Product Change Notice

PCN Ref Nº: PT-15 V with improved (flanged) collector

New flange close up

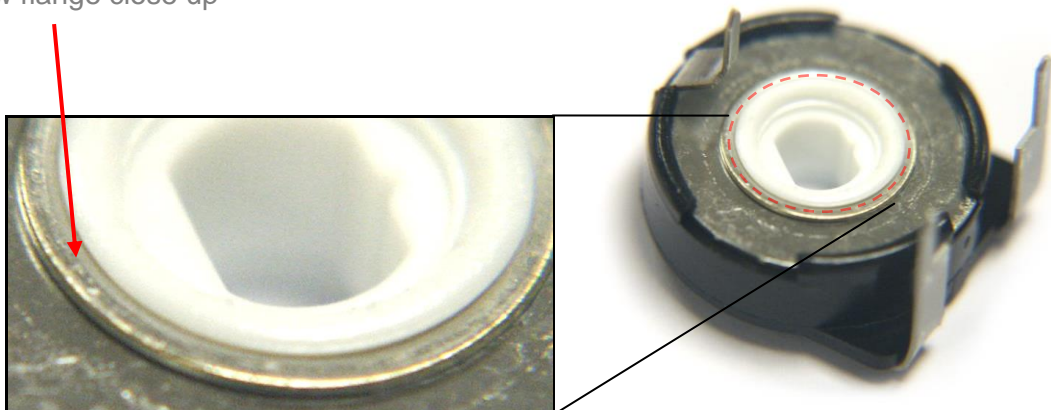
The collector for the PT-15 V model has been redesigned to include a flange near the rotor's hole. This change affords significant improvements in terms of rotational feeling and improved torque & hysteresis. All other product's specifications remain unaffected.

INVOLVED ARTICLES: All PT-15 V models **except V18 and V24**

REASONS FOR CHANGE: Improved rotational feeling. More homogeneous torque.
Improved hysteresis.
